# 1995 - 1996 Corvette: Service Bulletin: Transmission Fluid Leak From Pump Body

**Subject:** Transmission Fluid Leak From Pump Body (Replace Bushing)

**Bulletin Number:** 57-71-26B

Figure 1 - Hydra-Matic 4L60-E Transmission Identification Information

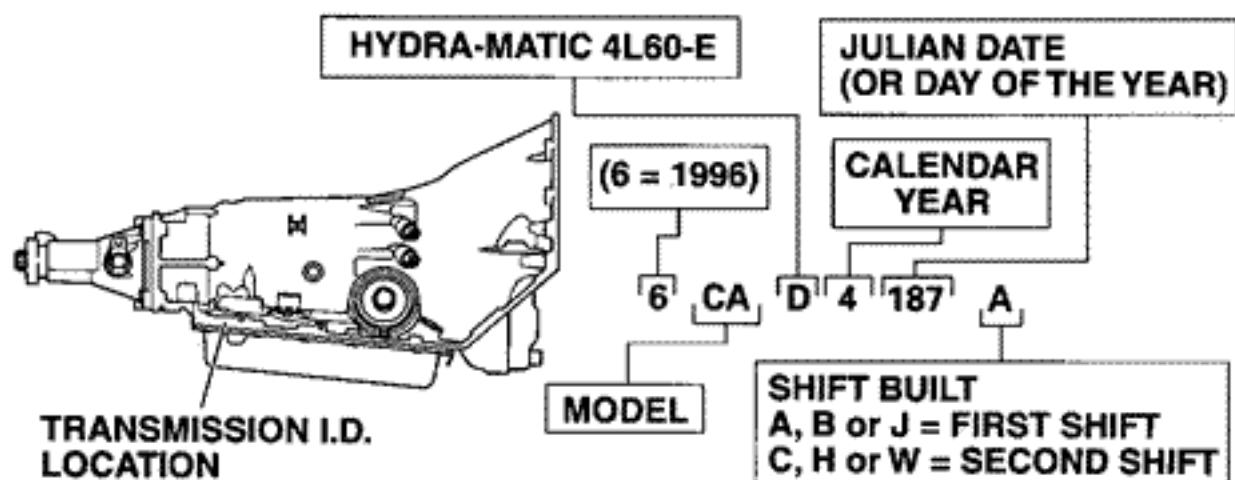
(FIGURE 1) SOME OWNERS MAY EXPERIENCE A PUMP FLUID LEAK. STARTING SEPTEMBER 11, 1995 (JULIAN DATE 254) ALL UNITS ARE BUILT USING A REVISED DESIGN BODY BUSHING.

THE PUMP BUSHING IS SPINNING OR WALKING OUT OF THE BODY.

REPLACE THE PUMP BODY BUSHING USING KENT-MOORE TOOL J41778.

**Figure 2 - Remove Front Helix Retainer**

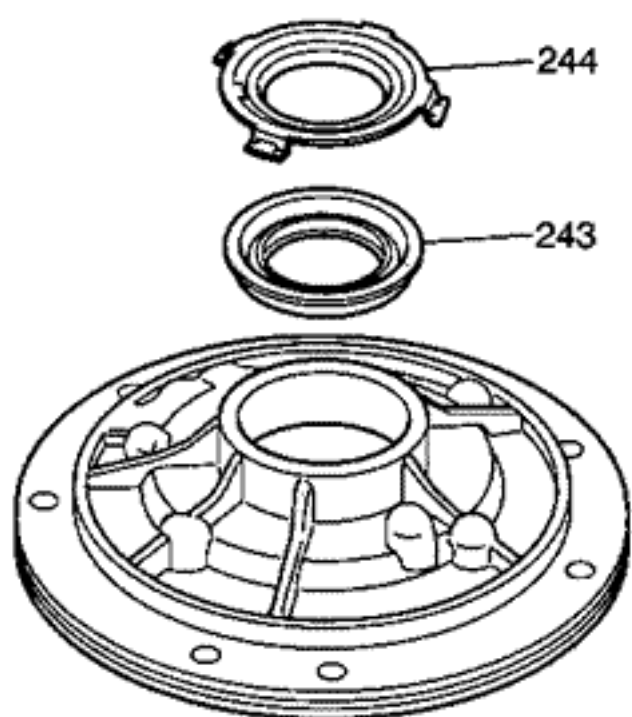
1. REMOVE THE FRONT HELIX RETAINER (244). 2. REMOVE THE OIL SEAL ASSEMBLY (243). 3. REMOVE THE PUMP BODY BUSHING (242) USING TOOL J41778-1. 4. INSTALL NEW BUSHING USING J41778-2 AS A POSITIVE STOP AND AN ARBOR PRESS WITH J41778-1.
